TENNESSEE VALLEY AUTHORITY

In the Matter of ) Docket Nos. 50-327  
Tennessee Valley Authority ) 50-328

ENCLOSURE  
ADDITIONAL RESPONSE TO THE NOVEMBER 18, 1985  
LETTER FROM E. ADENSAM TO H. G. PARRIS WHICH  
REQUESTED INFORMATION REGARDING THE INSERVICE INSPECTION PROGRAM  
FOR THE SEQUOYAH NUCLEAR PLANT  
DOCKETS 50-327 AND 50-328

Ultrasonic Scan Limitations

Figure 1

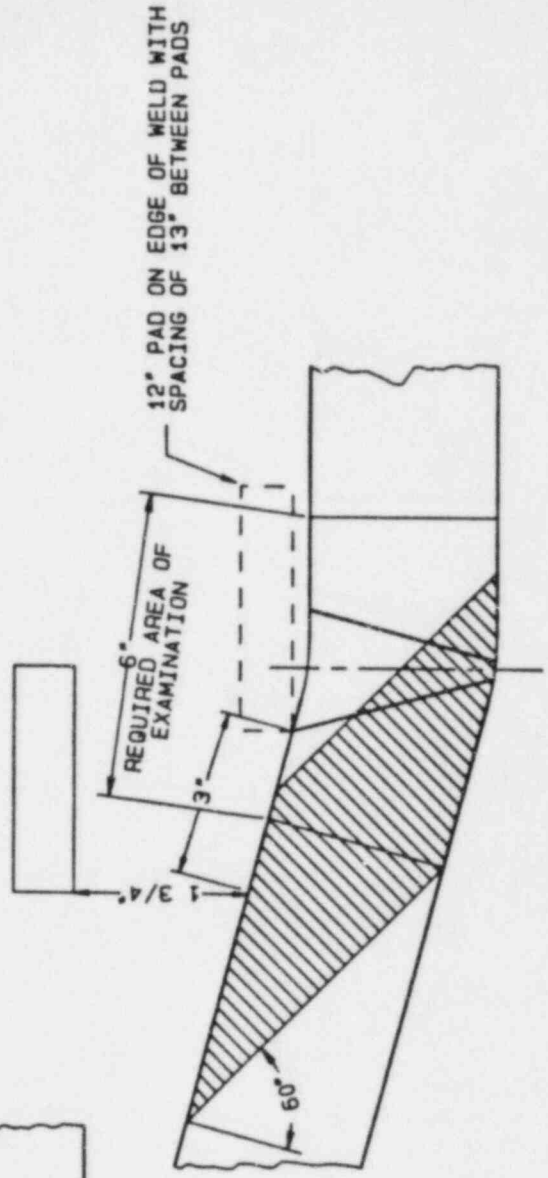
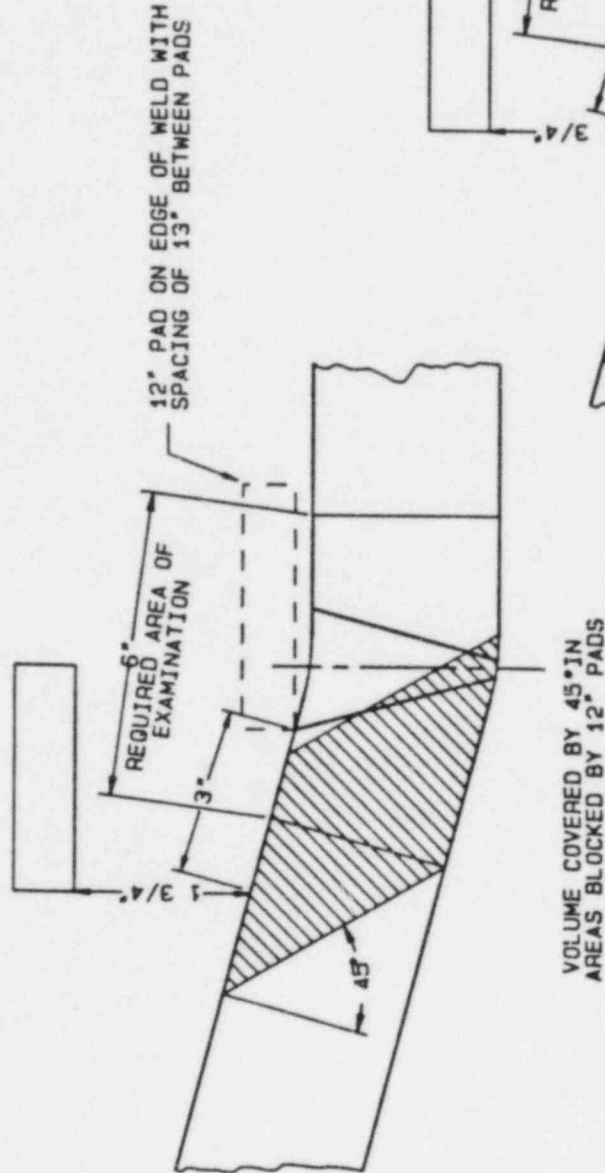
Relief Request No. ISI-4 states that one circumferential shell weld on each steam generator is inaccessible due to upper support brackets and that this weld will be examined on a "best effort" basis. The licensee provided drawings showing the support bracket causing interferences. However, the drawings are not of sufficient detail to ascertain the possible extent of examination. To enable evaluation of this relief request, the licensee should define the extent of the limited examinations that will be performed, including the volume of area, and provide dimensioned drawings with sufficient detail to enable the evaluation of the need for relief due to interference.

Attachment 1 provides a report detailing the physical clearances and estimated limitations to the steam generator ultrasonic examinations. This report also includes drawings which better define the physical dimensions in the steam generator lower core-transition circumferential shell weld areas.

Steam generator welds SGW-D1, D2, D3, and D4 are partially inaccessible for ultrasonic examination because of a permanent support ring located at the edge of the weld. The steam generator weld allows access for ultrasonic examination from the cone side only.

The support ring is held in place by wedging (1/2" x 6" x 12") steel pads between the support ring and the steam generator. These pads are spaced at approximate 13 inch intervals 360 degrees around the support ring. Approximately 42 percent of the weld had a greater limitation because of steel pads resting on the edge of the weld (see Figure 1). The remaining 58 percent of the weld was not blocked by steel pads; however, the clearance between the vessel and support ring precluded achieving 100 percent of the required volume from one side (see Figure 2). It was determined that at least 68 percent of the examination volume was examined despite support ring interference.

42% OF THE WELD IS BLOCKED WITH THE 12" PADS

VOLUME COVERED BY 60° IN AREAS BLOCKED BY 12" PADS
